SUBJECT: 25-040 Loaf Land Subdivision - Comment Response

Thank you for your continued review of the Subdivision Application Permit (SP 4103) for Loaf Land Subdivision in Coplin Plt.. The team recently received the additional review comments from LUPC in regard to this application, dated August 27, 2026. These comments can be seen below in *italic*, followed by Main-Land's response in regular typeset. Updated or amended exhibits have been provided as attachments.

“LOAF LAND SUBDIVISION” AT MOUNTAIN ROAD, COPLIN PLANTATION, MAINE

S2.1

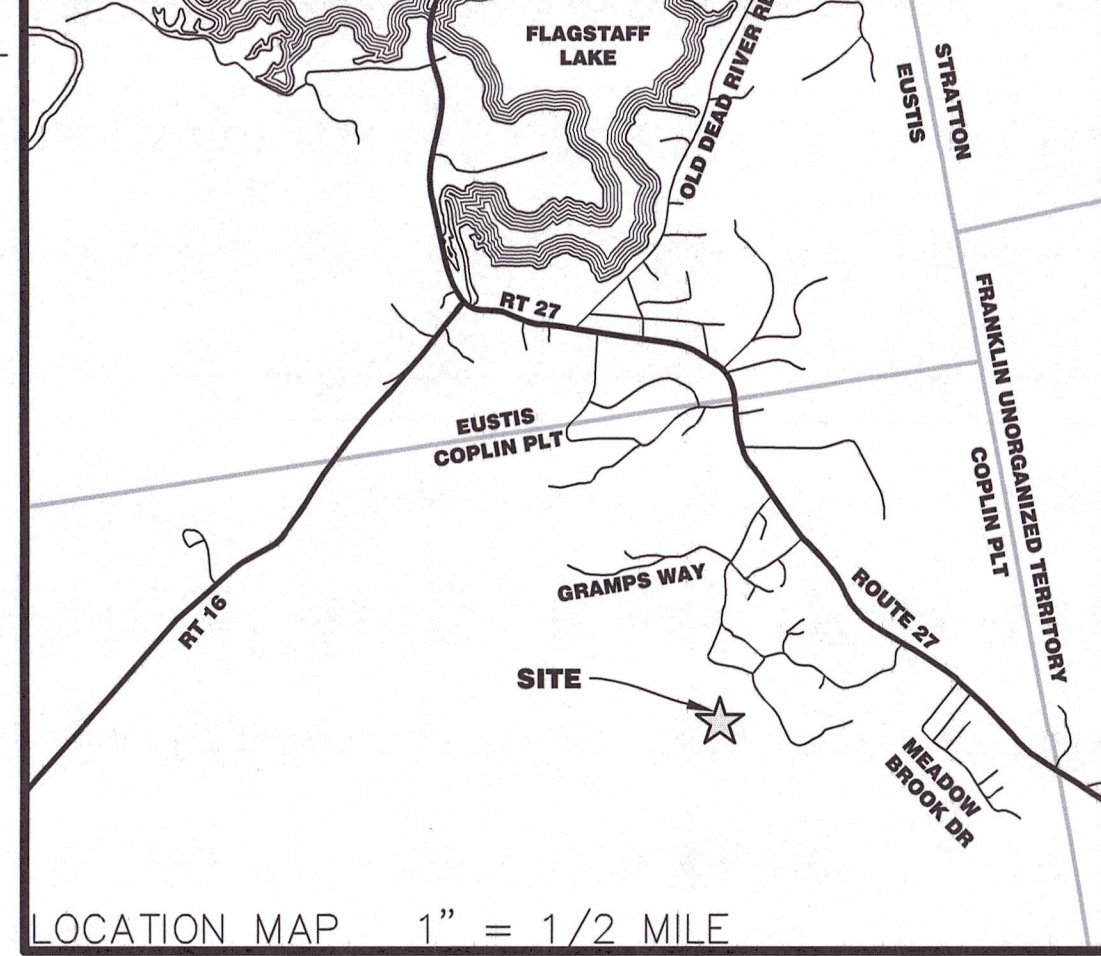
- *Wetland Alteration Supplement (Ex. 35)*
 - *Clarify the amount of wetland impact proposed. The Subdivision Plan (Ex. 10, S2.1) shows 354 sq ft (Note 11), the Grading Plan (Ex. 10, C3.1) shows 374 sq ft, and the Wetland Alterations Supplement (S-3) shows 514 sq ft proposed (Q. 7).*

S2.1 Subdivision Plan has been amended to include a septic test boring within the building envelope.

There is 990 sf of Forested Wetland impact and 160 sf of Stream impact, resulting in a total of 1,150 sf. All plan denotations have been updated to match the updated Form S-3.

C3.1

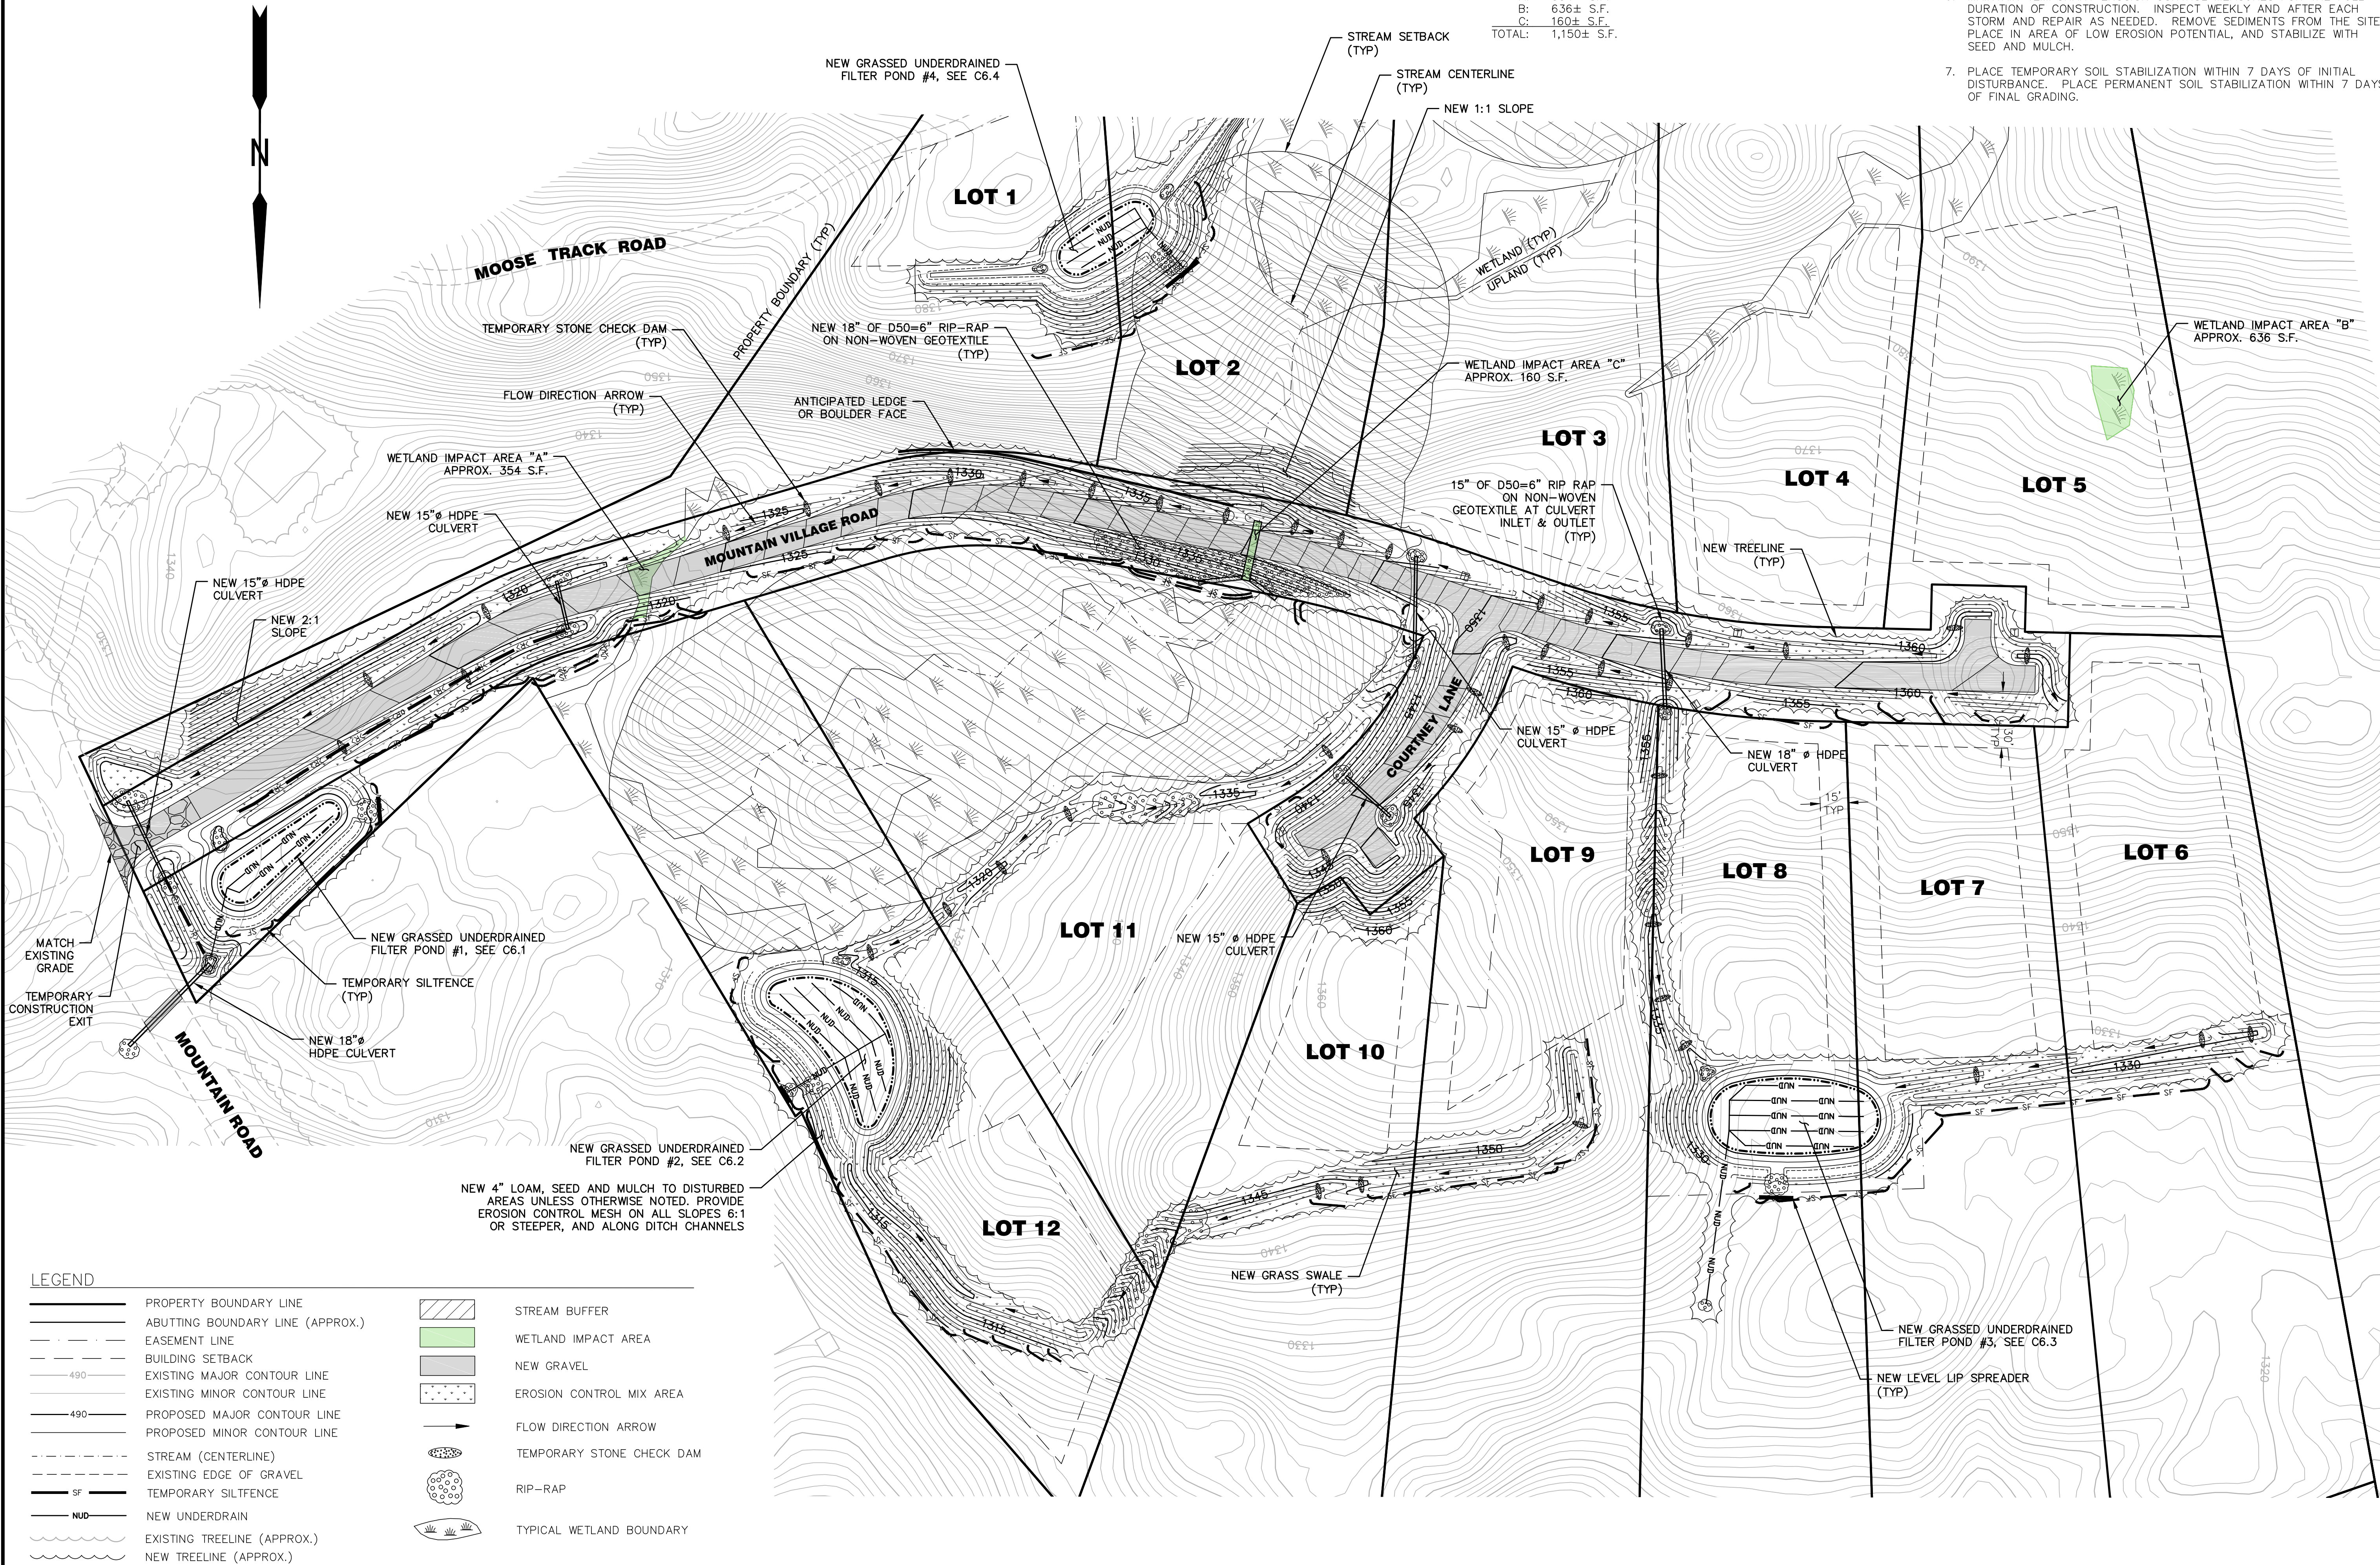
- *On Plan C3.1 (Grading & Erosion Control Plan), wherever side slopes exceed 3H:1V, show the planned slope stabilizing measures and their extents (see Sebago Technics review comment IV.11 on Sheet C5.3).*
 - *Sebago Response: The stream profile appears to indicate the need for a 7 foot-tall wing wall on the outlet side. The plans should better depict the design intent of this wingwall and how wetland impacts will be avoided during its construction. Silt fence is also shown through the wetland in this area with no stated wetland impact in this area. Additionally, the design plans include lengths of side slopes that are at 2H:1V or steeper. It should be shown on the grading plan which slope stabilizing measures are to be used and their extents where the side slope exceeds 3H:1V.*

The design plans have been updated accordingly to reflect those areas.

**ROAD PLAN
AND PROFILE**

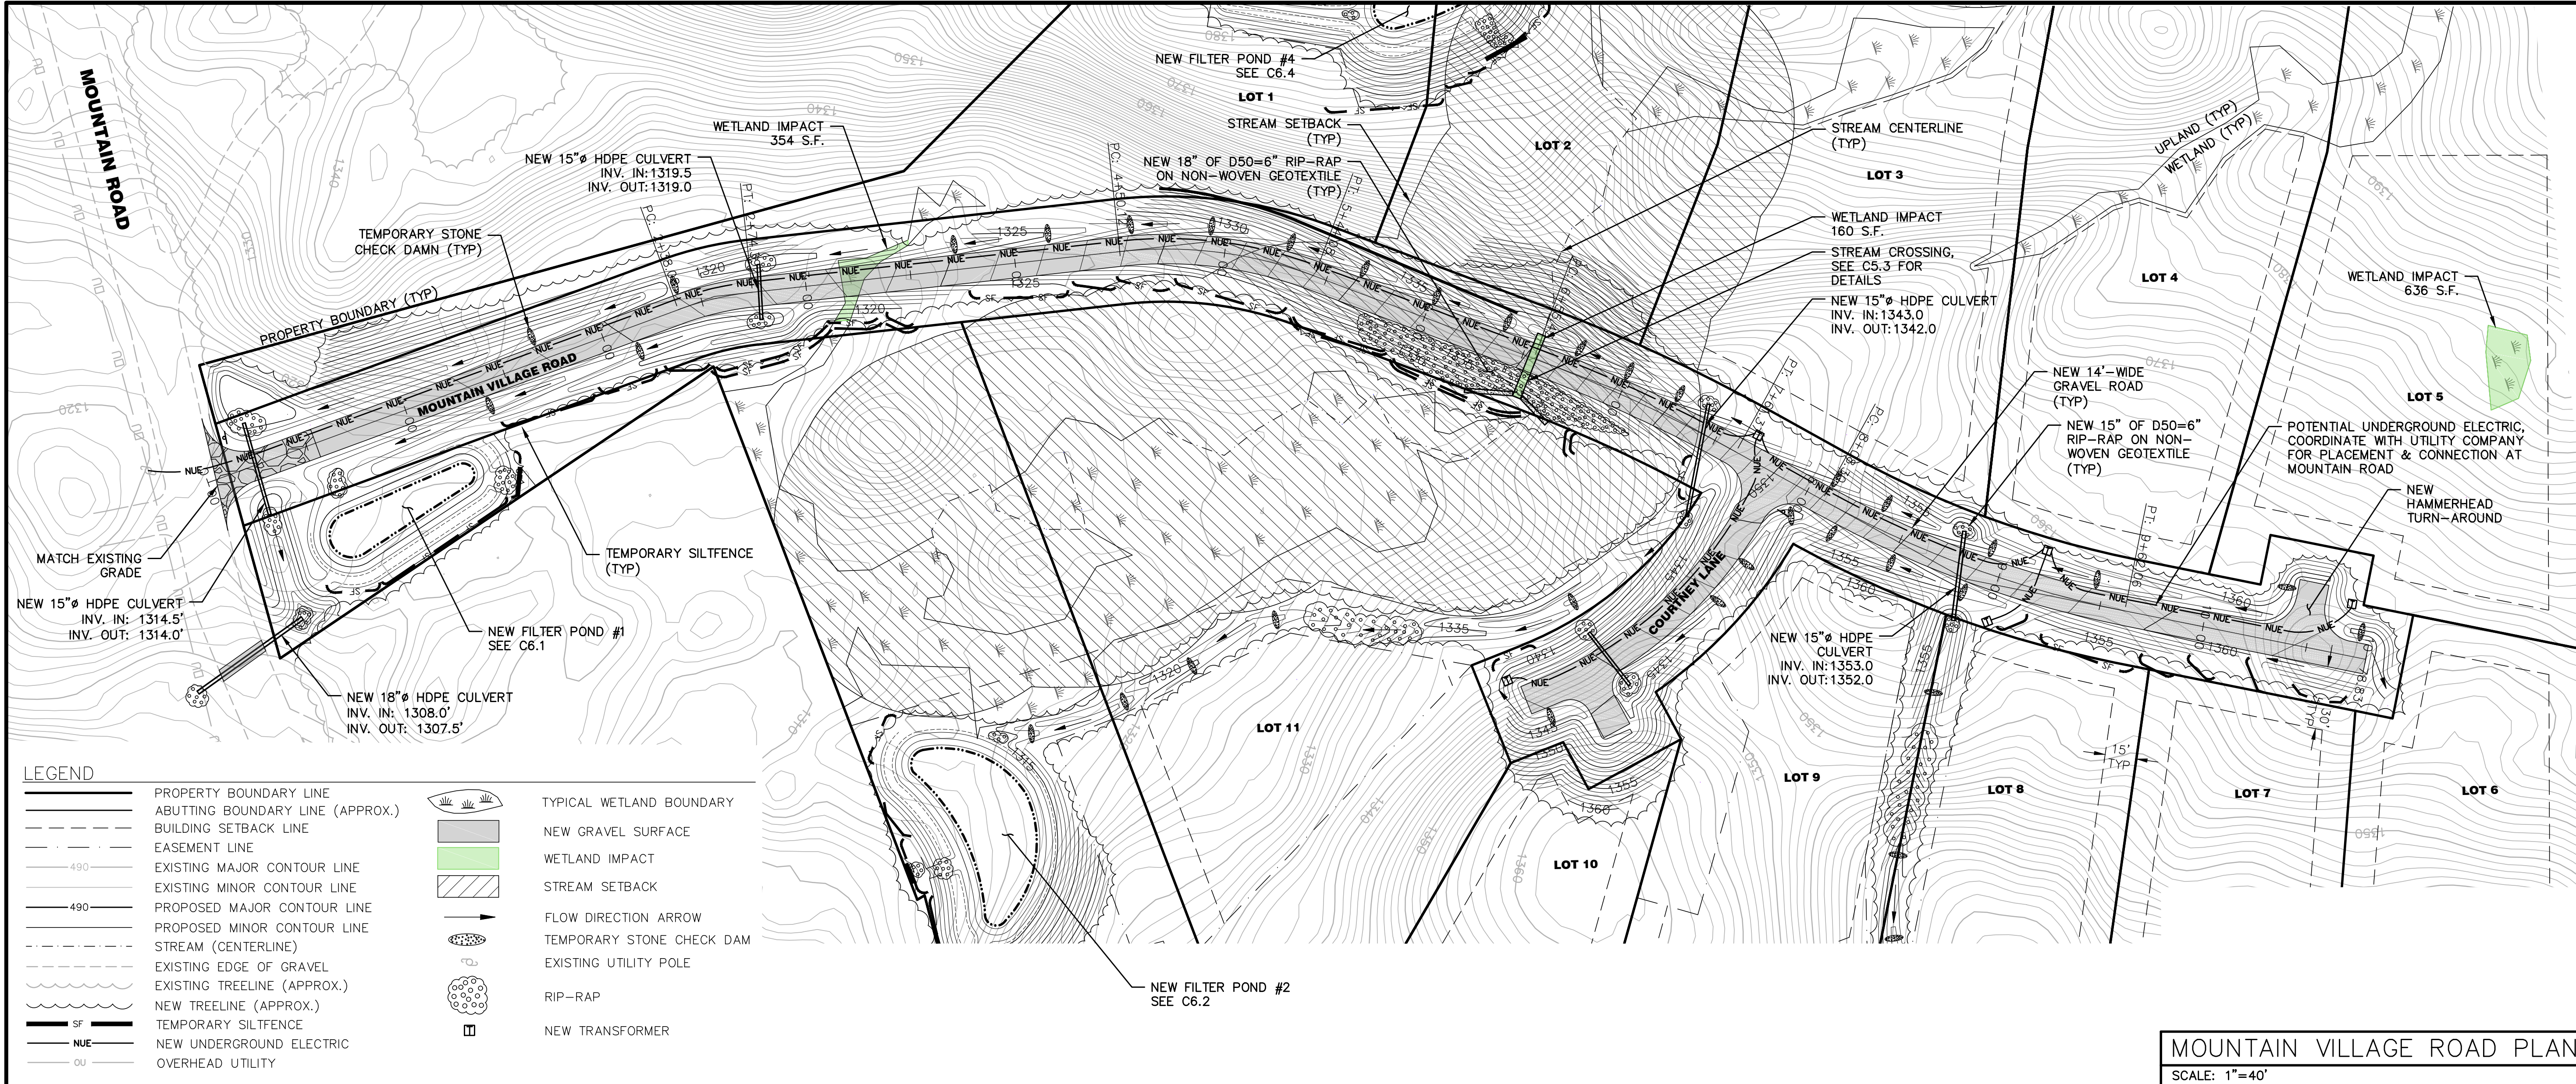
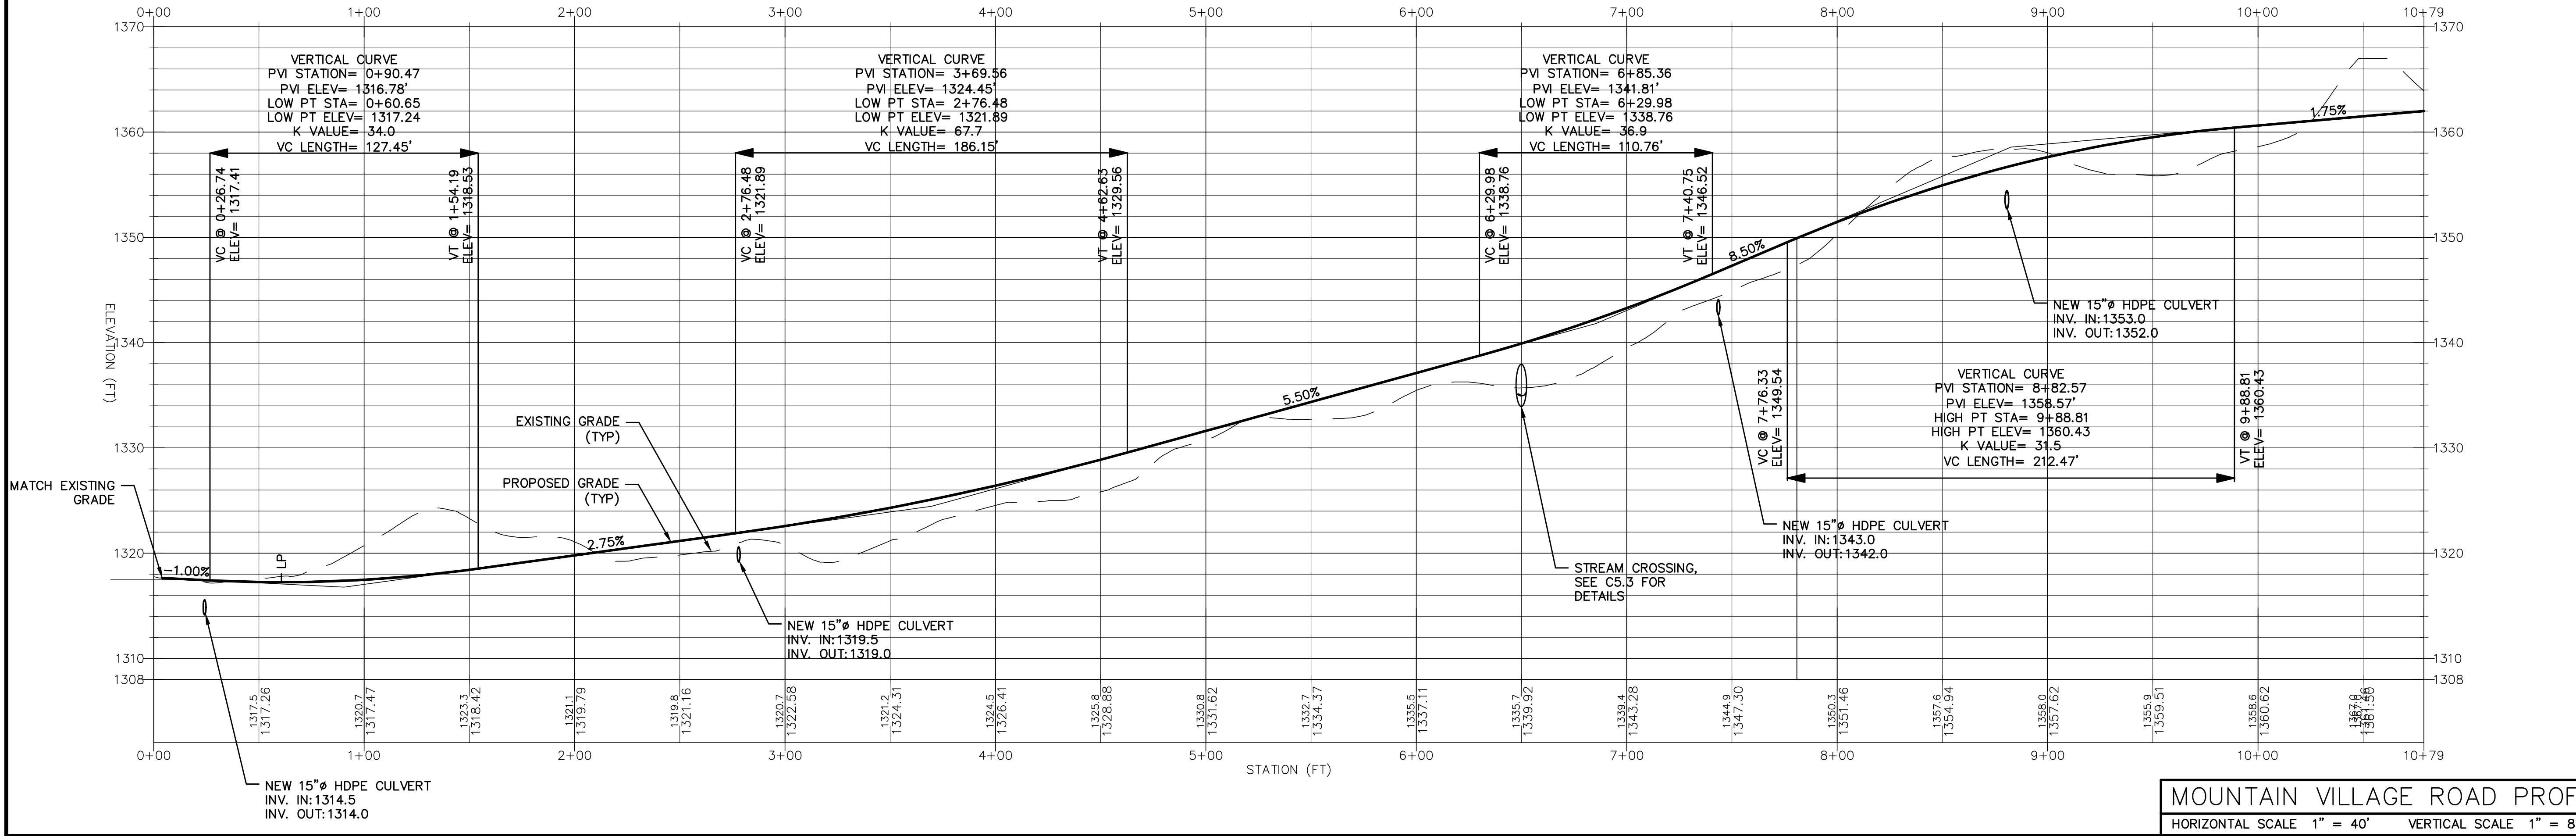
- *On Plan C5.1 (Road Plan and Profile), consider moving the proposed underground electrical conduit to either side of the ditch (see Sebago Technics review comment IV.12 on Sheet C5.1).*
 - *Sebago Response: The proposed electrical conduit is shown running down the centerline of the roadside ditch for Mountain Village Road. The designer should consider moving the conduit to either side of the ditch to avoid shallow cover and water intrusion.*
